Shimizu Engineering Report

Project	General Electric Company ESBWR Project	Shimizu Document No.	SER-ESB-038
Title	Modified RBFB Truncated FE Model Analysis Data	Rev.	1
		Issued Date	9/22/06
		Revised Date	9/28/06

This document provides the data for the truncated Reactor/Fuel Buildings Finite Element (FE) model analysis in response to NRC's request in the DCD audit for RAI 3.8 held on July, 2006. The requested data was originally issued by SER-ESB-027. NRC reviewed it and requested some simplification and clarification. This document provides the data modified in accordance with NRC's request.

Figure 4-1 Modification in Truncated Model

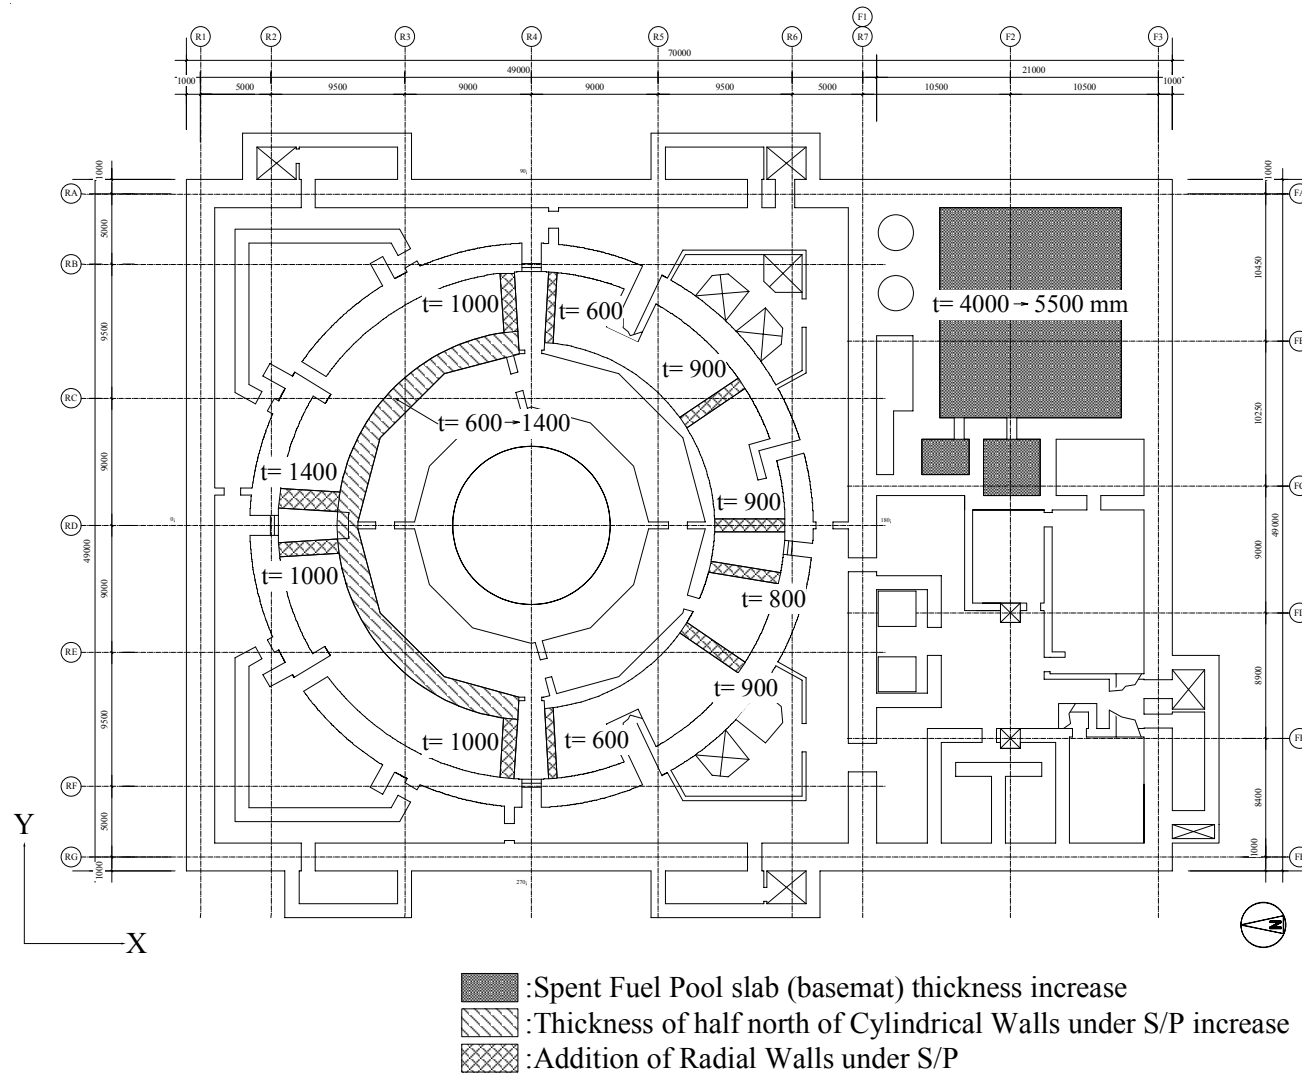
The following modifications were made for the truncated model. They are summarized in Figure 4-1.

- Increase of Spent Fuel Pool slab (Basemat) thickness
- Increase of cylindrical wall thickness at the half north side under the Suppression Pool
- Addition of radial walls under the Suppression Pool

The region of the Spent Fuel Pool slab is shown as the dot pattern in Figure 4-1. The thickness of slab elements is increased from 4.0 m to 5.5 m as shown in Figure 4-2.

The cylindrical wall at the north side, i.e. from 90° to 270°, under the Suppression Pool is indicated as the diagonal line pattern in Figure 4-1. Its thickness increased from 0.6 m to 1.4 m as shown in Figure 4-2.

The radial walls shown as cross diagonal line pattern in Figure 4-1 are added to the modified truncated model. Their thicknesses are shown in Figure 4-1. The radial walls in the modified truncated model are shown in Figure 4-2.
